Our Case Number: ABP-309770-21

**Re: Proposed development of up to 15 wind turbines with a tip height of up to 175 metres and laying of approximately 26km of underground electricity cabling to facilitate the connection to the national grid, and all associated site development works
Townlands of Camagh, Carlanstown, Coole, Clonrobert, Clonsura, Doon, Monktown, Mullagh, Newcastle and other townlands, Co. Westmeath**

Please find attached an Observation on Further Information on case Nos 309770-21 Coole Wind Farm SID.

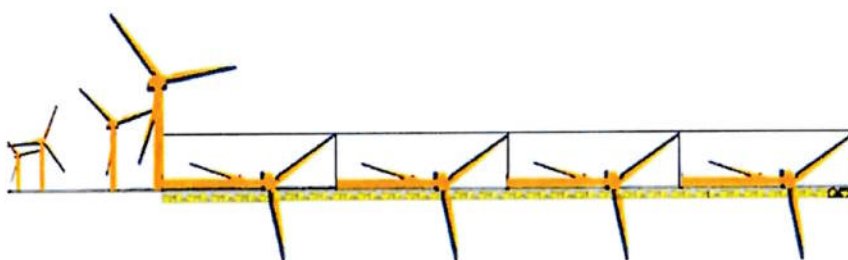
In the illustration below using the exact scale drawings include in CWF's submission we have attempted to illustrate the approximate size and distance the nearest of these turbines would be to our home in Clonsura. Whilst we acknowledge the image does not take into account geographical landscape features that whilst relatively flat would mitigate some of the impact of these turbines it is self-evident that their scale combined with noise and shadow flicker will have a seriously detrimental impact on our lives and those of other residents who will be forced to even closer proximity to these turbines.

11. An equally important point is that if we can produce such a visual representation despite lacking the resources, time and expertise of CWF why, if they are indeed serious about addressing the concerns we and others have, do they not use their nearly limitless resources to provide a proper visual representation of how their 175 metre turbines will likely impact on the people unfortunate forced to live in close proximity to the proposed industrial wind farm?

Fig.1 is a scale drawing estimating the size of the proposed turbines in comparison to our home based on the minimum 1/4 setback distance which for 175m turbines equates to 700 metres from tip height to tip height. Our home in Clonsura is located approximately 760m from the nearest turbine. The above illustration gives some idea of the scale of the turbines in relation to the height of our home based on its approximate size of 25m x 7m. It should be noted that the size of the turbines are based on CWF's scale modelling but the turbines may be even higher as it is unclear on their drawings where the base of the turbines end.

Fig.2 is a larger scale drawing of the size of the proposed turbines if they were sited beside our home, which would be 23 times its height. We estimate that 700 metres would approximately equate to 28 times the length of our home.
